UNITED STATES PATENT AND TRADEMARK OFFICE

APPLICATION NO.	FILING DATE	FIRST NAMED INVENTOR	ATTORNEY DOCKET NO.	CONFIRMATION NO.
10/723,569	11/26/2003	Wolfgang Beigang	GKNG 1184 PUS	9113

Office Action Summary	Application No.	Applicant(s)	
	10/723,569	BEIGANG, WOLFGANG	
	Examiner	Art Unit	
	Lan Nguyen	3683

DETAILED ACTION

FIG. 6

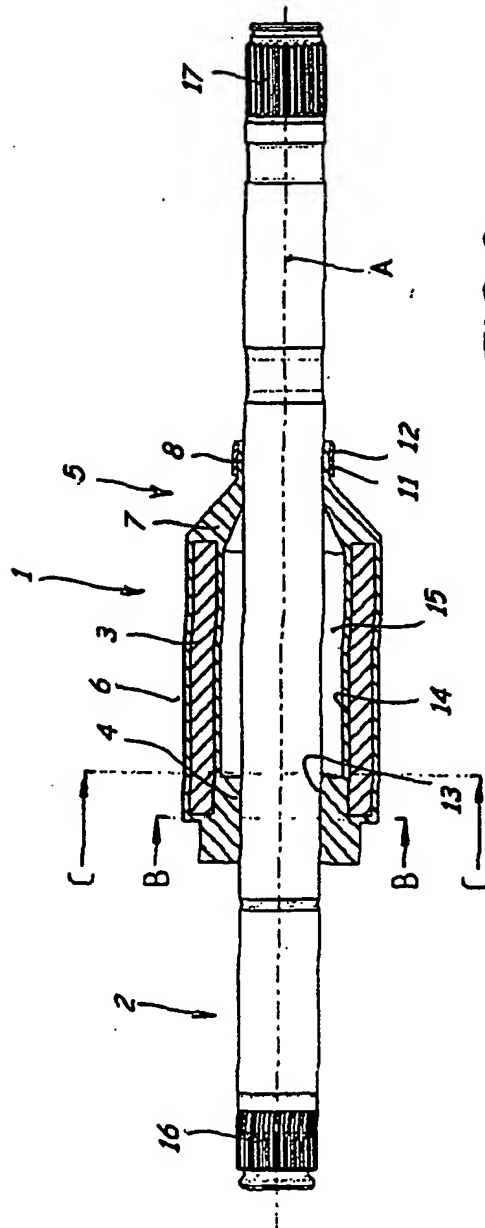
1. The drawings of figures 6-8, submitted 8/5/05, have been approved.

9. Applicant's arguments filed 8/5/05 have been fully considered.
- Applicant's argument regarding the rejections under 112, 1st paragraph and 112, 2nd paragraph have been found persuasive. The rejections have been withdrawn. The new drawings of figures 6-8 and the amendments to the specification have been approved.

approved
XUN 11/7/05
